Applicant requests a Special Exception under Section 2.16.050 K (Carport over a Driveway) in an R-4 (Residential) zone.

The request is for a 24' by 17' carport of which a 24' by 10' portion is proposed to encroach in the required front yard setback and to be located to within 11' of the front property line.

Site plan

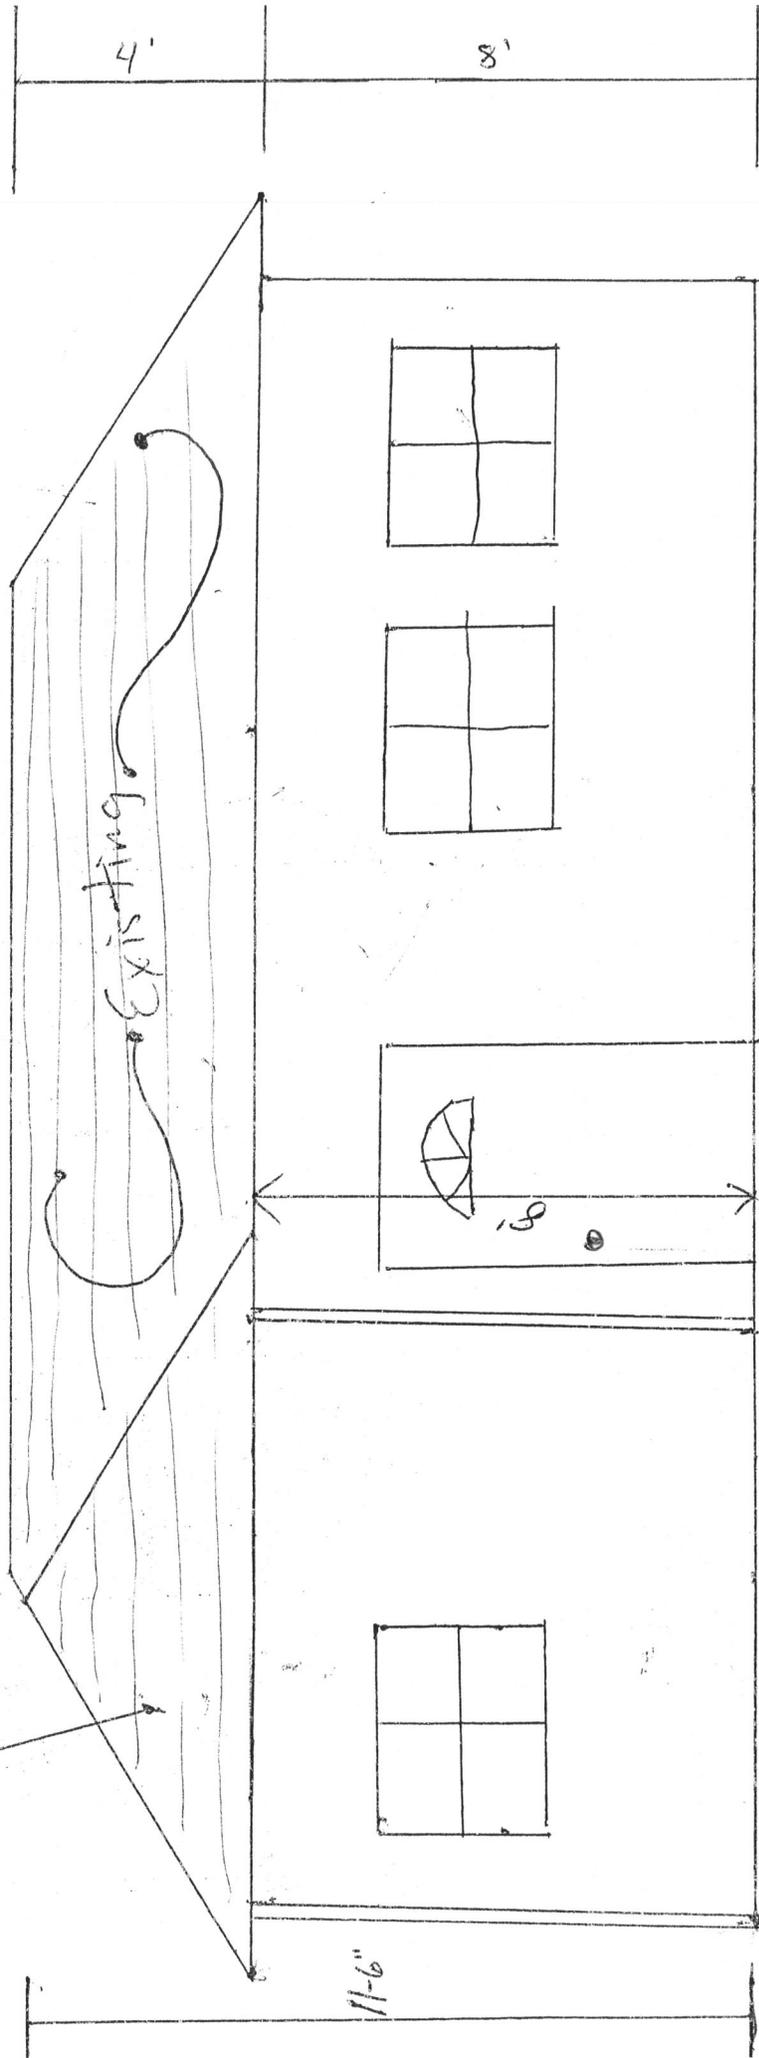
Staff recommends approval of the request for the Special Exception, pending BP&I's structural review, and with the condition that a carport shall not be permitted over the second driveway on the site.
